THE CLEVELAND ELECTRIC ILLUMINATING COMPANY

Perry Nuclear Power Plant
Docket Nos. 50-440; 50-441
Confirmatory Issue - No. 16
Limiting Weld Material

This letter and its attachments are provided in response to the Perry SER confirmatory issue numbered 16. This response addresses limiting beltline weld materials as well as revises the responses to the NRC questions 123.1, 123.2, and 123.3.

Surveillance Bracket

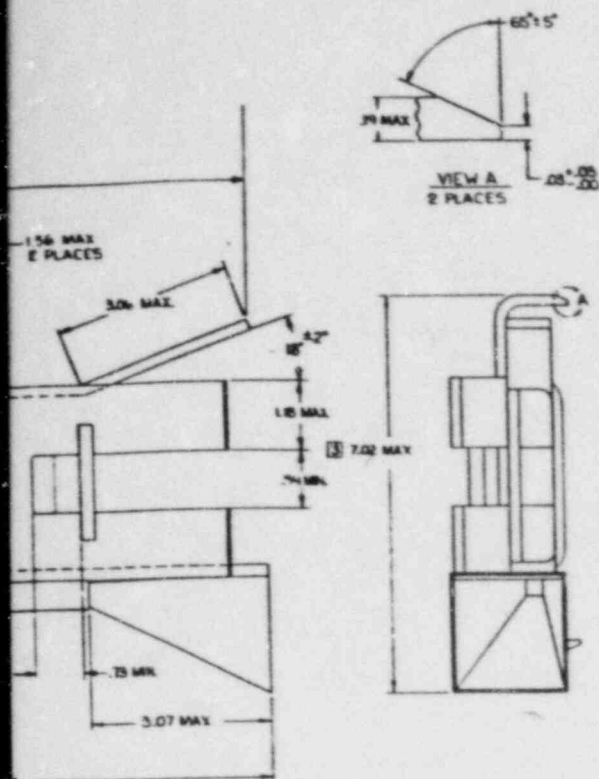
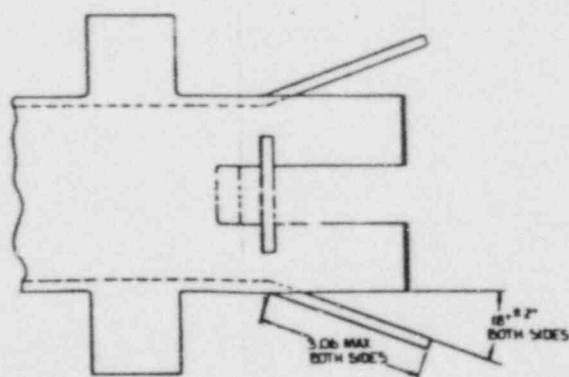
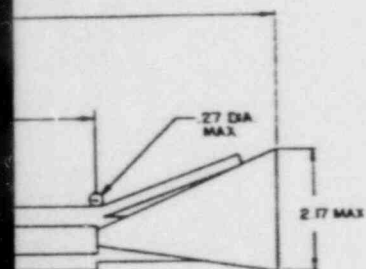
- (a) Provide a sketch showing the azimuthal location of each material surveillance capsule.
- (b) Identify each plate specimen in each capsule by heat number and chemical composition, especially copper and phosphorus.
- (c) Identify each weld specimen in each capsule by weld wire type and heat, flux type, lot identification, and chemical composition, especially copper and phosphorus.
- (d) Identify the lead factor for each surveillance capsule.

Surveillance capsule contents and locations are:

<u>Capsule No.</u>	<u>Azimuth</u>	<u>CHARPY SPECIMENS</u>			<u>FLUX WIRES</u>	
		<u>Transverse Base</u>	<u>HAZ</u>	<u>Weld</u>	<u>Fe</u>	<u>Cu</u>
1	3°	12	12	12	2	2
2	177°	12	12	12	2	2
3	185°	12	12	12	2	2

Three Fe flux wires are also contained in a separate neutron dosimeter at the 3° location.
